UNITED STATES PATENT AND TRADEMARK OFFICE

10/643,055

Office Action Summary

DETAILED ACTION

Fig. 2

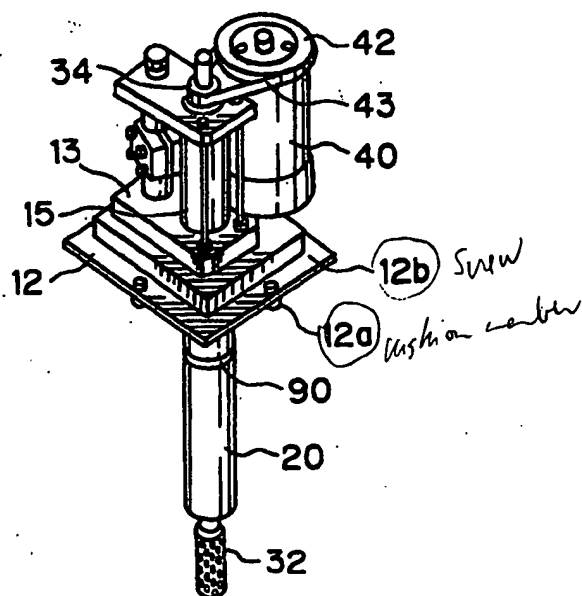
For claims 12 and 25, Kajisono discloses said agitator comprises at least one blade (40-50 of col. 4 and Figure 7) extending from a lateral surface of said drive shaft that is rotatably driven by said motor.

9. Applicant argues that Kajisono does not teach an agitator that stirs water retained within a water retention structure, the Examiner disagrees. As shown in lines 40-50 of col. 4 and Figure 7, Kajisono discloses that "it is preferable to provide impellers" or agitation members outwardly extending from a lateral surface of the distal end of the drive shaft (30) and the motor rotates the agitation members (note that when the impellers/agitation members rotate the water surrounding the impellers/agitation members will be stirred (see Figure 7 attached at the end of this Office Action for further explanation).
